Approved Section 4.55 (1A) Modification Application

1 Denison Street
North Sydney, NSW 2060

Site Plan

Scale	1 : 500	@ A1
Drawn	MDJ	Checked AD
Project no.	s12055	
Status	Development Application	
Plot Date	9/05/2018 12:04:37 PM	
BIM	1DENISON_BS_ARCH	
Drawing no.	DA01.000	Revision 5

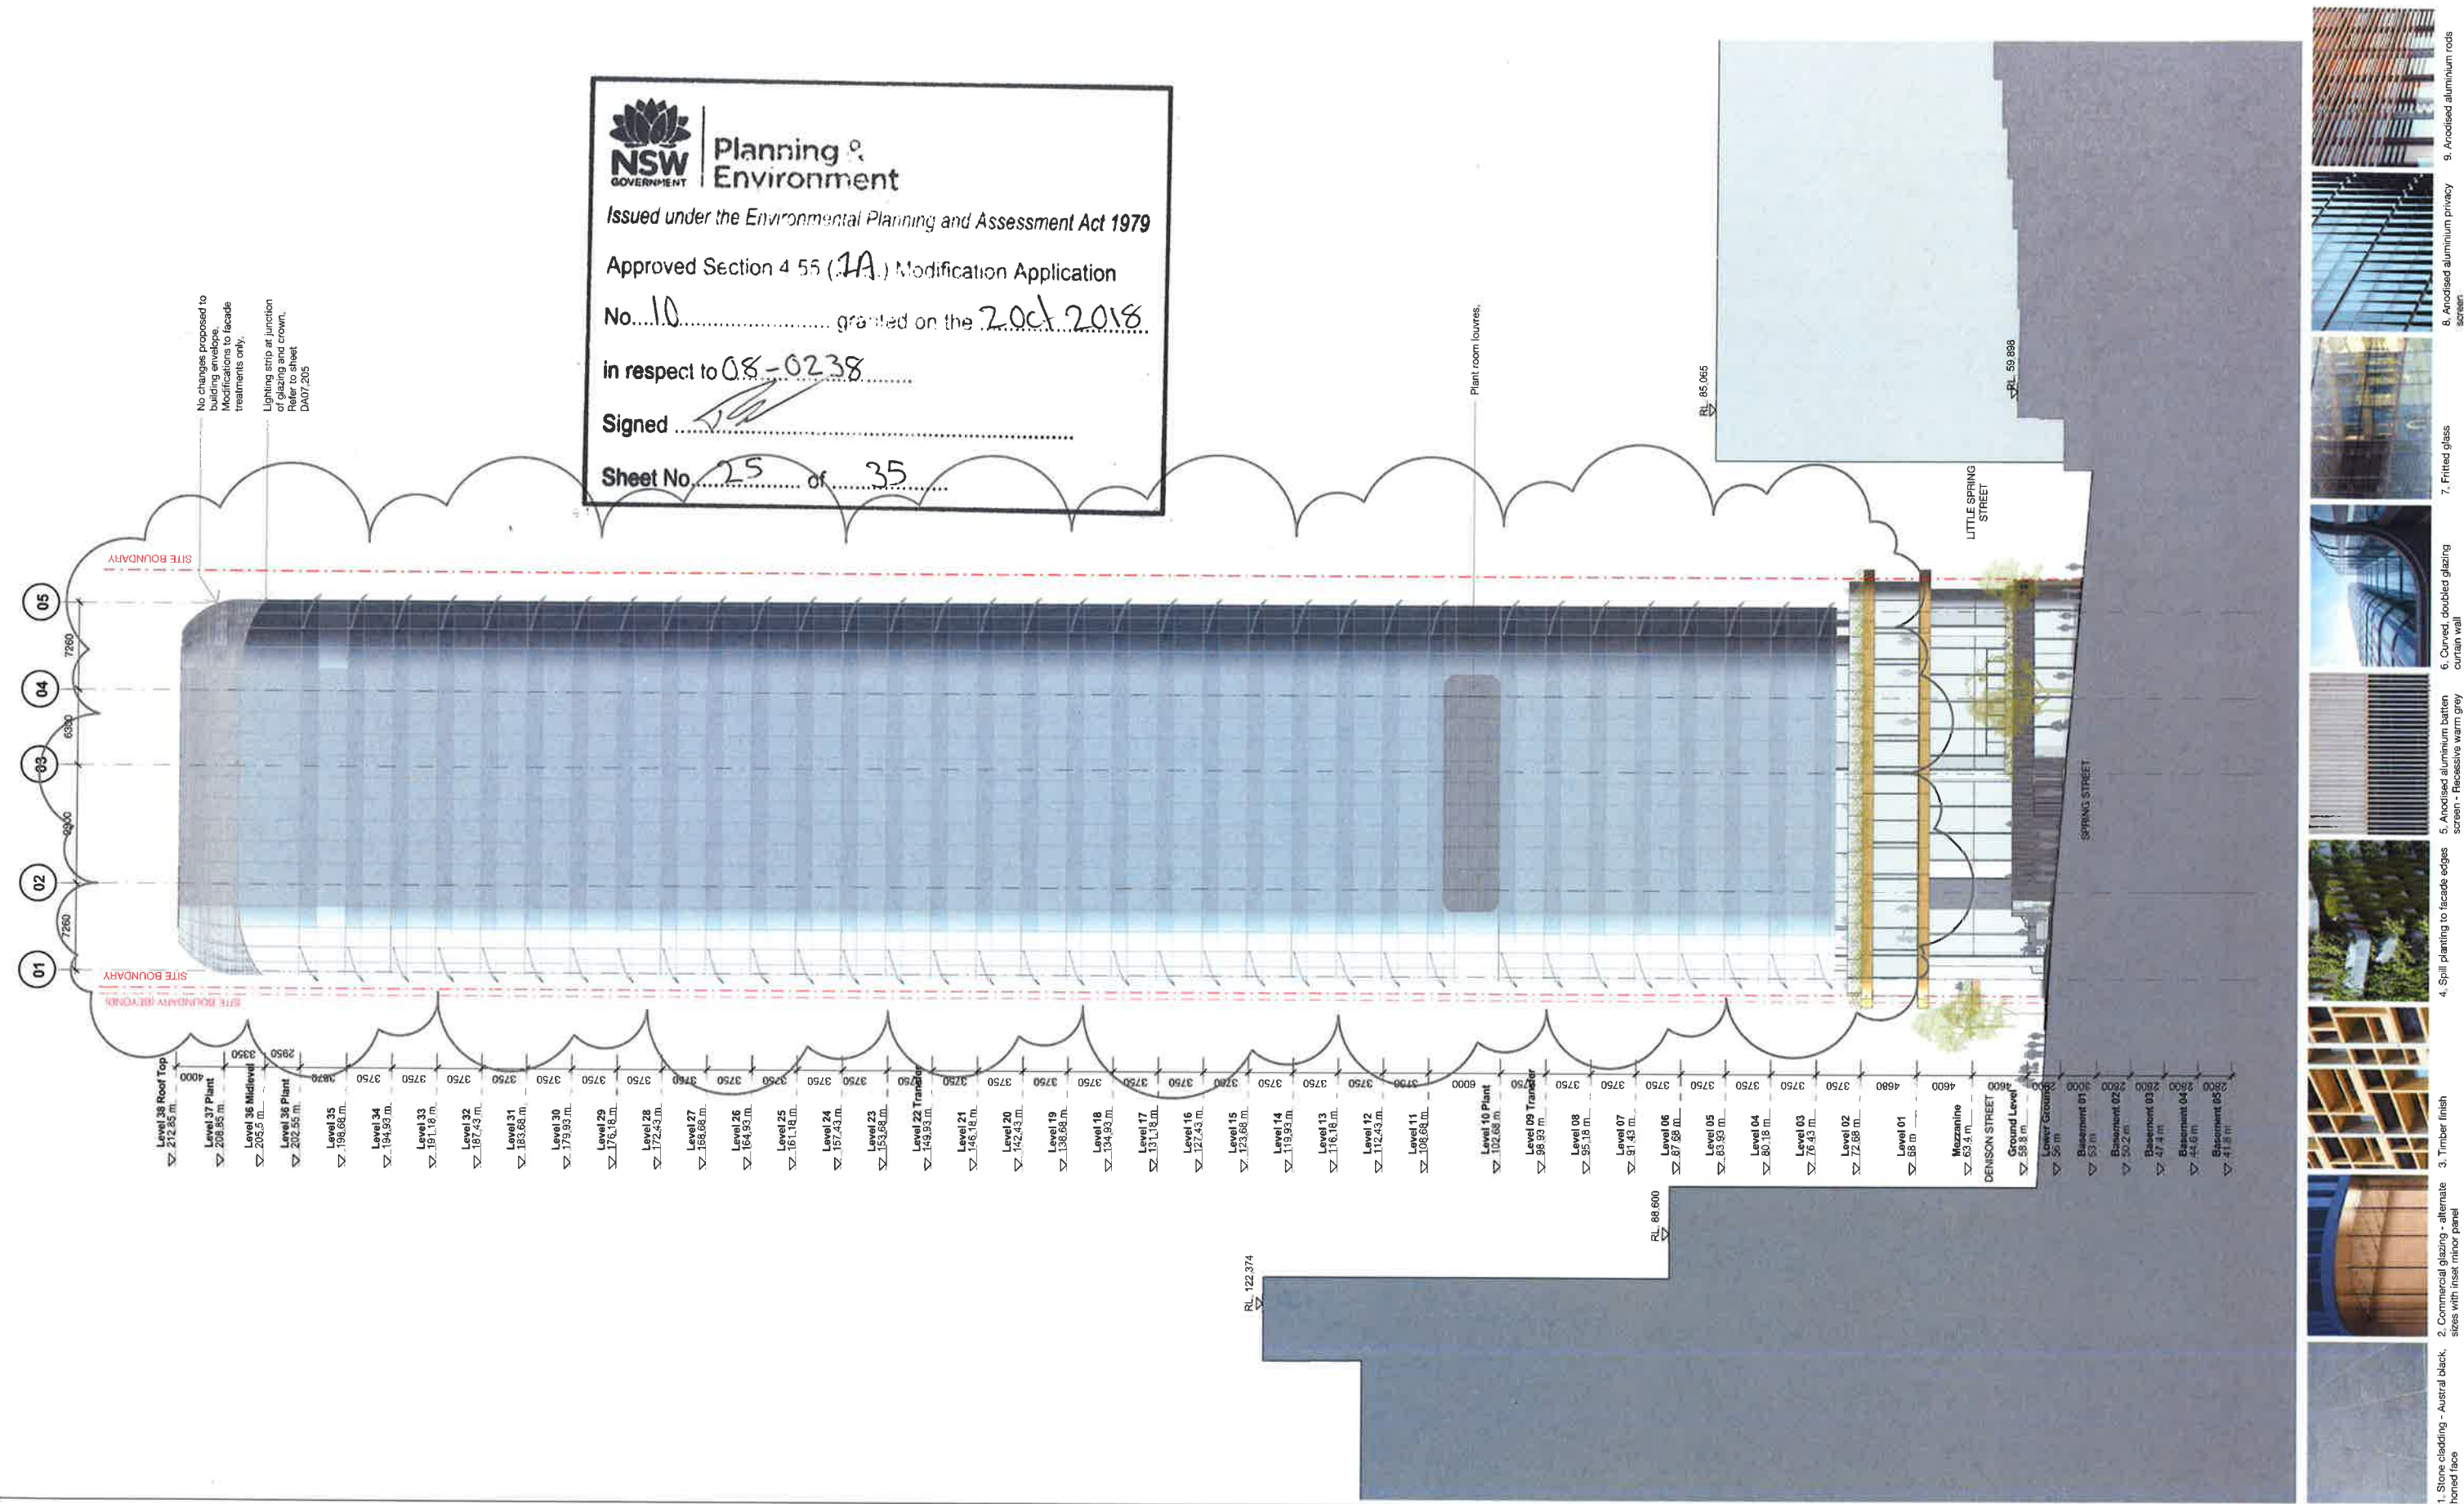
No changes proposed to building envelope or facade treatments only.
Lighting strip at junction of glazing and crown.
Refer to sheet DA07.205
Alignment of lower edge of rooftop crown has been adjusted on east and west facades

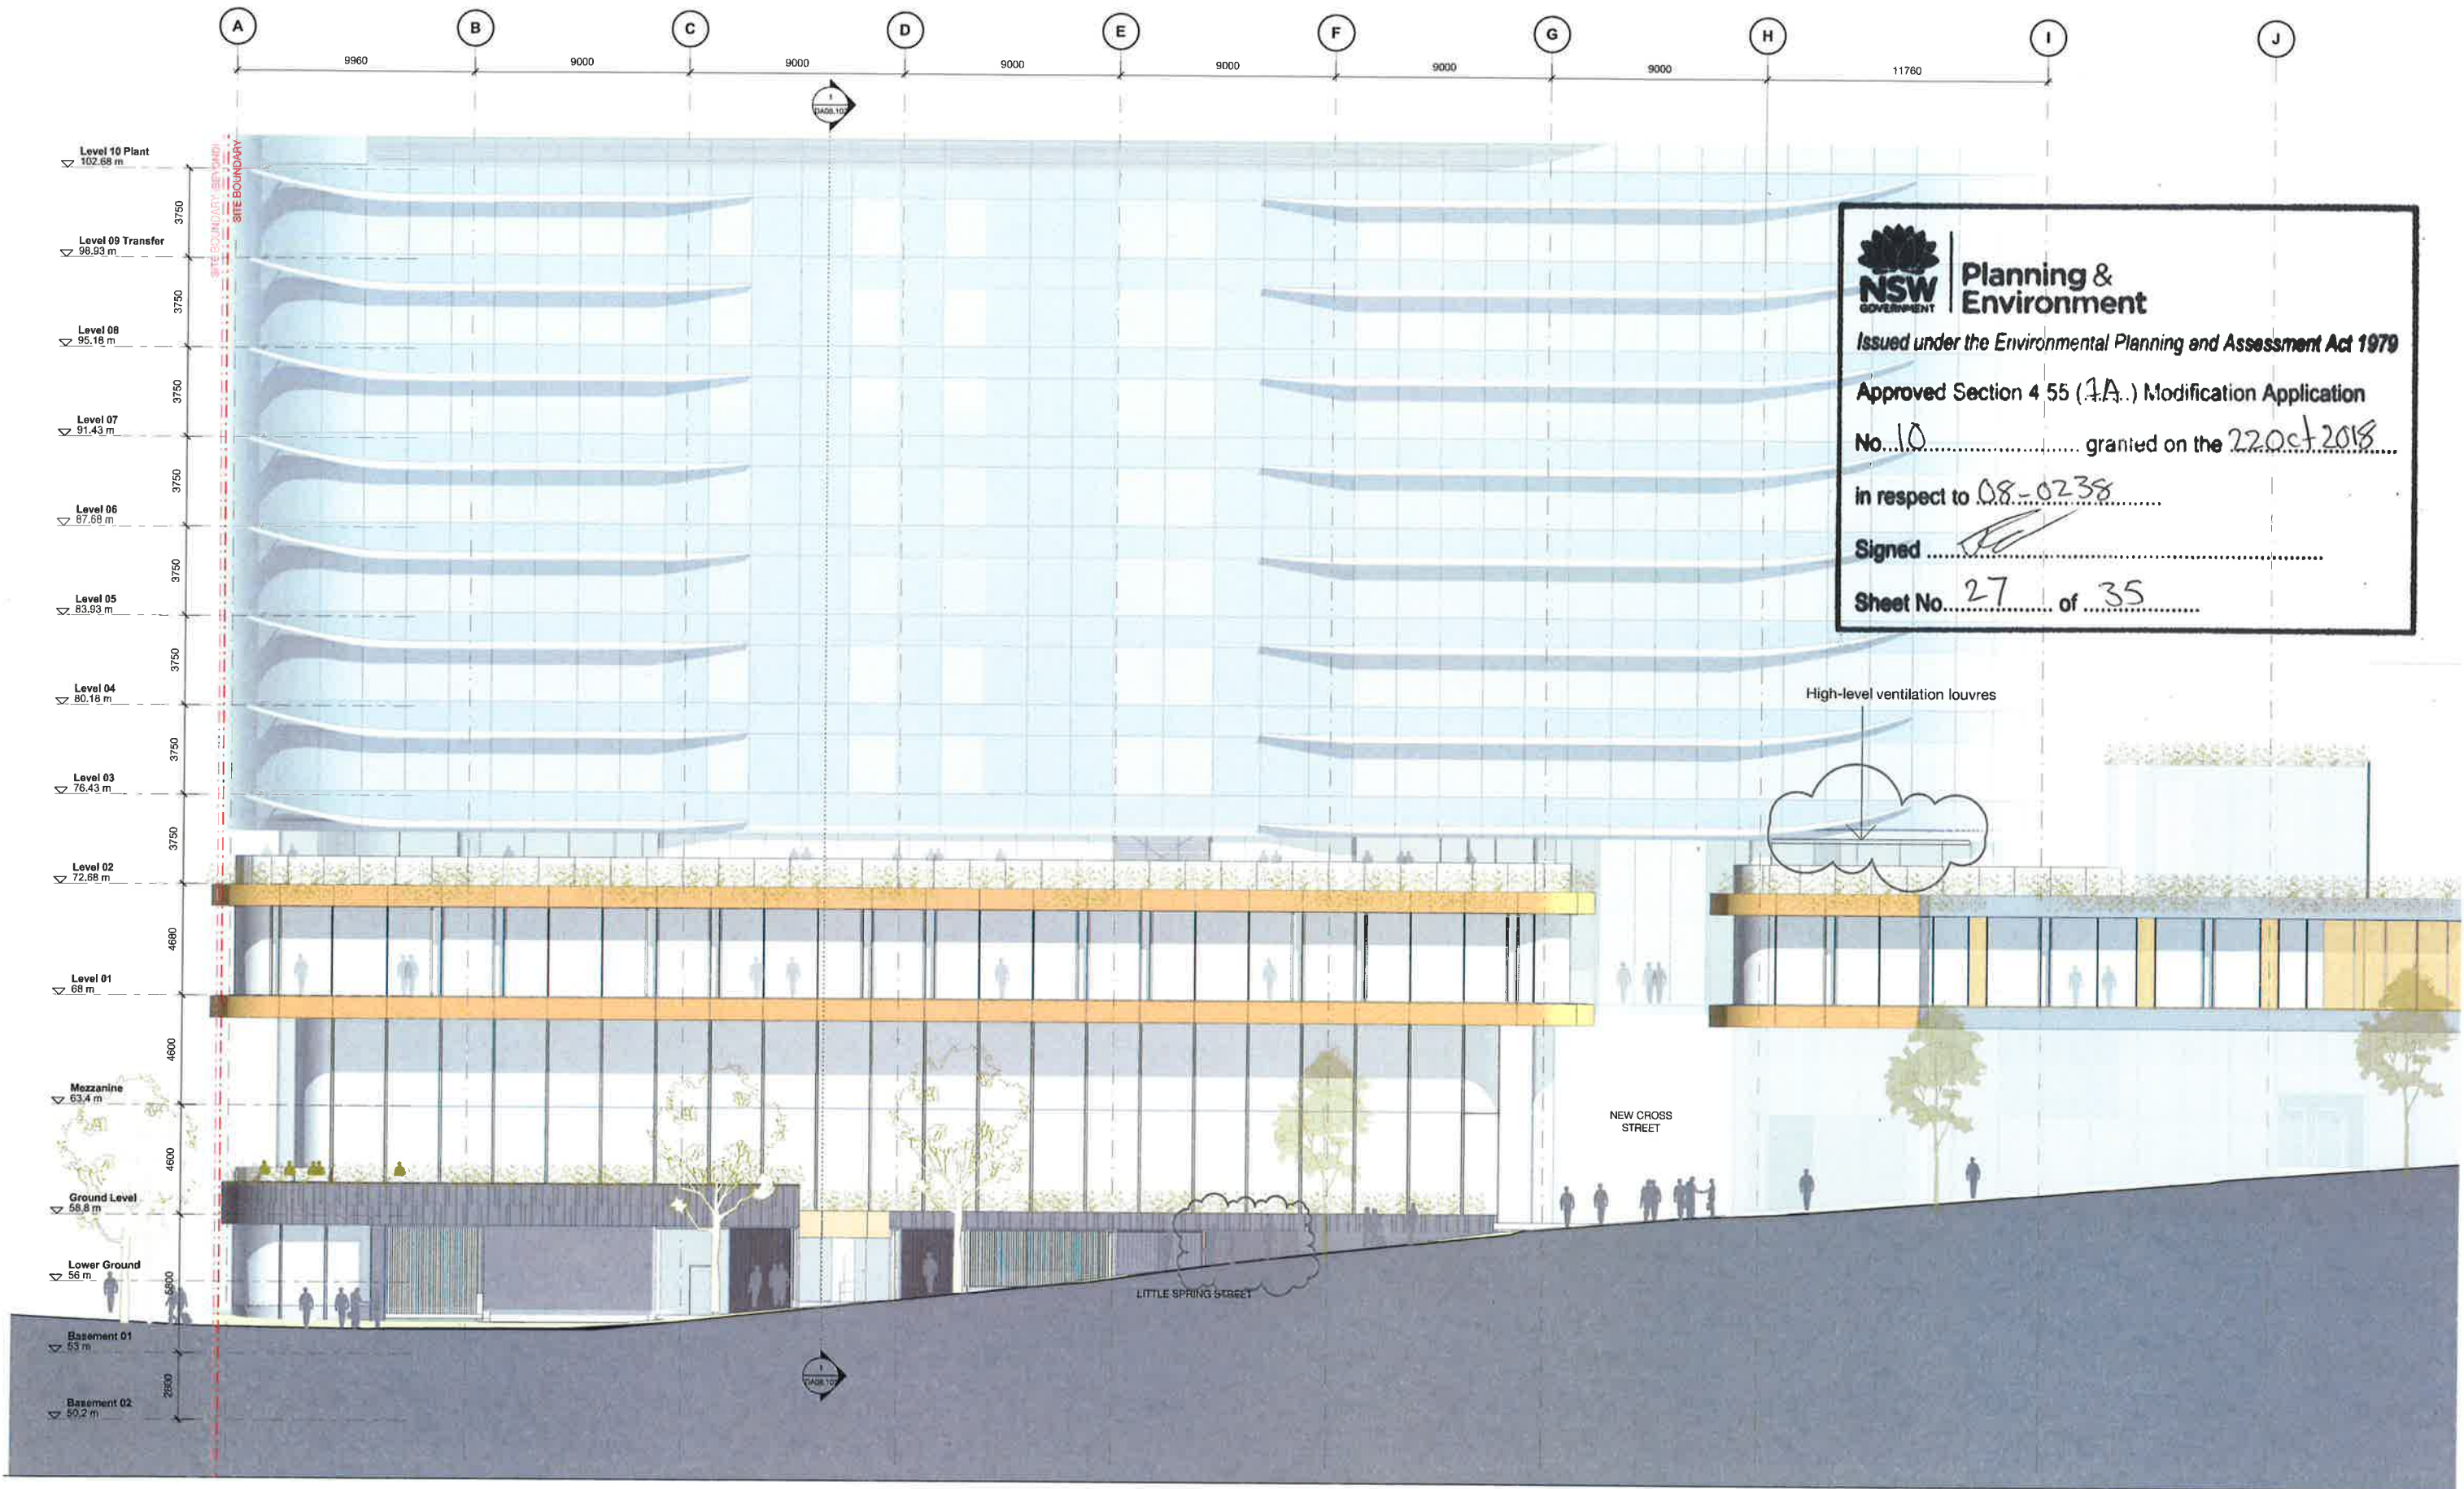
No changes proposed to building envelope. Modifications to facade treatments only.

Lighting strip at junction of glazing and crown. Refer to sheet DA07/205
